CITY OF ALBUQUERQUE

Brewer Oil Redevelopment RE: 3200 Richmond Dr. NE **Grading and Drainage Plan** Engineer's Stamp Date: 06/15/21 Hydrology File: H16D154

Based upon the information provided in your submittal received 06/15/2021, the Grading & PO Box 1293 Drainage Plans are approved for Building Permit and Grading Permit.

BUILDING CORPORATION OF AMERICA COMPLEX GRADING AND DRAINAGE PLAN

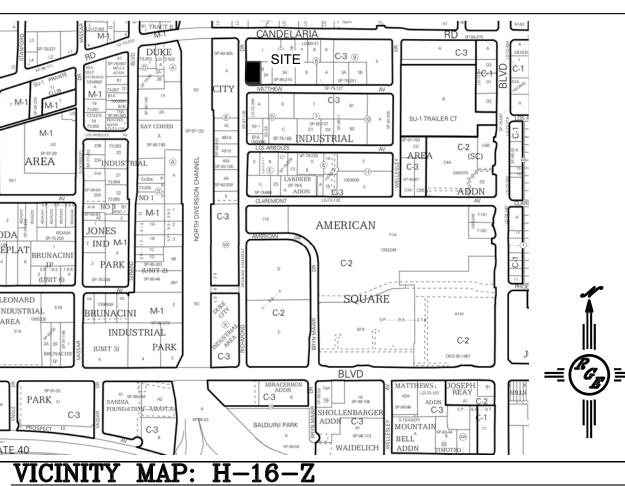
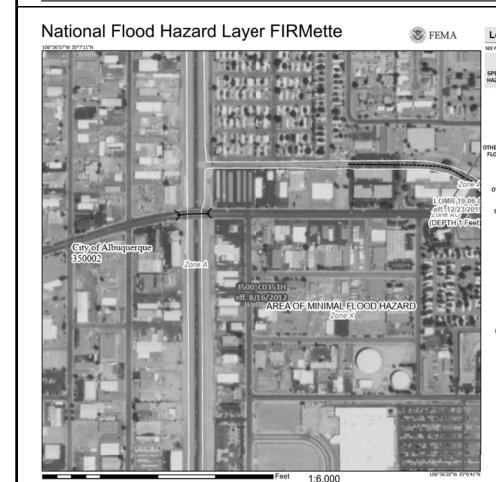
> Please provide Drainage Covenant for the stormwater quality pond per Article 6-15(C) of the DPM prior to Permanent Release of Occupancy. Please submit an electronic file of the Covenant and Exhibit for completeness to Marion G. Velasquez at mgvelasquez@cabq.gov. Once the electronic file is approved for completeness, please submit the original copies along with the \$ 25.00 recording fee check made payable to Bernalillo County to Marion on the 4th floor of Plaza de Sol. Please note that Hydrology will need a pdf copy of the recorded Drainage Covenant prior to Hydrology's approval of Permanent Release of Occupancy.
